VERIFICATION REPORT AND CERTIFICATION STATEMENT

**Gansu Huanghe Bingling Hydropower
Station Project**

Subject:			
VCS 2007.1 Project Verification			
Verification Team:			
Ginger Jiang Yuan – Lead Assessor		☒ No Distribution (without permission from the Client or responsible organisational unit)	
Michael Wu Shimin – Assessor			
Yolanda Zheng – Expert/Local Assessor		☐ Limited Distribution	
Technical Review:			
Date: 18-01-2010		Name: Not Applicable	
Name: Joe Sun			
Authorised Signatory:			
Name: Siddharth Yadav		☐ Unrestricted Distribution	
Date: 16 th April 2010			
Revision Number:	Date:	Number of Pages:	
0	18-01-2010	50	
1	-	-	
2	-	-

Indicative electric connection diagram of the project activity:

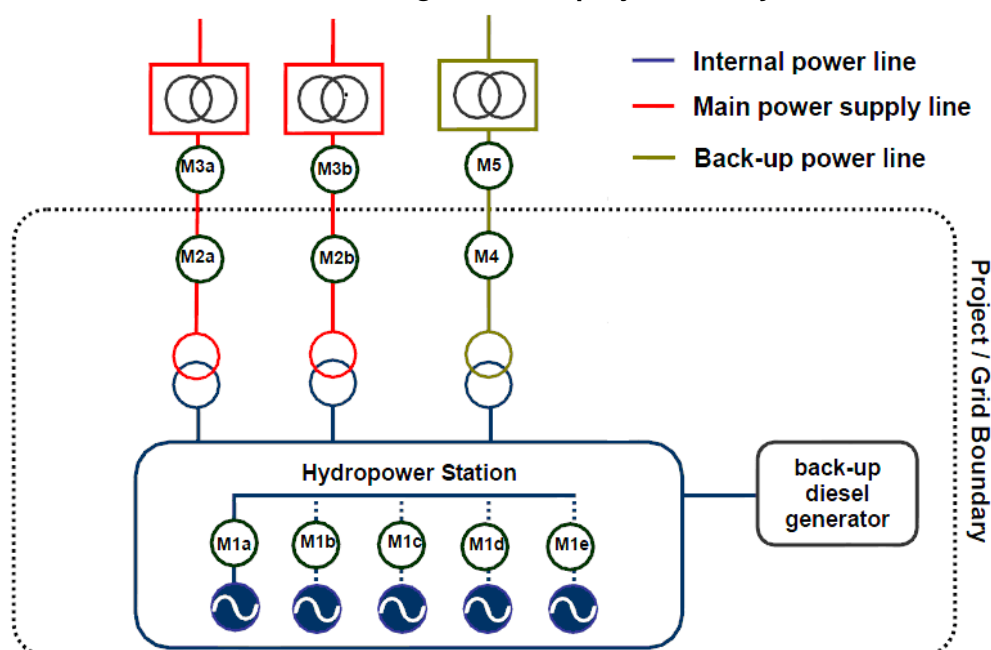
As per figure B.3 in page 31 of the PDD, the electricity supplied to and imported from the grid through the two main lines (Line 1 to the 110kV Transformer Substation and Line 2 to the 330 kV Transformer Substation) are monitored by two main meters (M3a on line 1 and M3b on line 2) which are used for electricity transaction purpose and two backup meters (M2a on line 1 and M2b on line 2). The electricity imported from the grid through the backup line (Line 3 from the 35 kV Transformer Substation) is monitored by the main meter (M5) and by the backup meter (M4).

CL #3 was raised for the lack of information about the meters monitored by the grid company (M3a, M3b and M5) and their calibration in the Monitoring Report version 1. PP clarified by providing the related information in the MR version 2. Detailed calibration information is as follows:

The calibration certificates (/11/13/) and Metrological Authorization Certificates of the calibration entities (/12/14/) were present for verification. It is verified all the meters have been calibrated annually by accredited third party as per the description in the registered monitoring plan. **CL #3 was closed.**
